# Technical Service Bulletin MHTSB-2022-01

## Subject: Emergency Bypass Control Switch Upgrade

Replacement of the Exhaust-port filter fitting on the MH 2ip/4ip Emergency Bypass Control (EBC) Switch Assembly

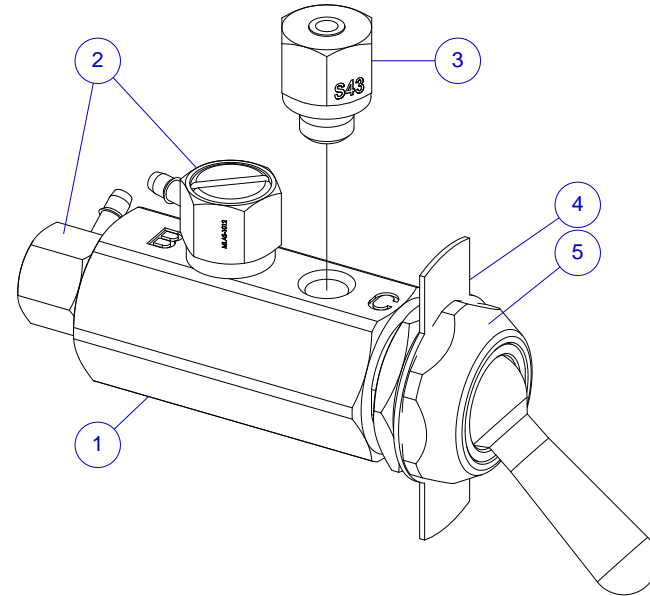
Under some circumstances the EBC outlet (4mm/Red tubing) of the remote regulator (IPR) may fail to shut off and oxygen will continue to flow when the EBC switch is cycled to the "OFF" position. This can be attributed to excessive restriction in the exhaust-port filter installed at Port "C" of the EBC Switch which prevents the control line from properly purging in the "OFF" condition.

- Turn the oxygen system OFF before proceeding.
- You will need sufficient access to the EBC Switch (Item 1) to allow you to remove and replace the Exhaust-port Filter (3) installed at Port "C". In some situations you may be able to do this without removing the EBC Switch from the panel. Otherwise, remove the Dress Nut (5) and Legend Plate (4) and remove the EBC Switch from the rear of the panel.

- Remove the existing Exhaust-port Filter (3) installed at Port C and replace it with the new one provided by MH (5/16 Hex). If you have a suitable torque driver, torque the new fitting to 7 in-lbs - otherwise "snug" (do not over-tighten).

Replace the exhaust-port filter with a less-restrictive one.

A replacement exhaust-port filter should be provided with this Bulletin. Otherwise, contact MH Customer Service to request the replacement part. Note that the "old" part may be variously marked "05" / "F05" / "MB-05", whereas the new replacement part is marked "43" / "S43" / "MBS-43" allowing the 2 items to be distinguished should they become mixed-up.
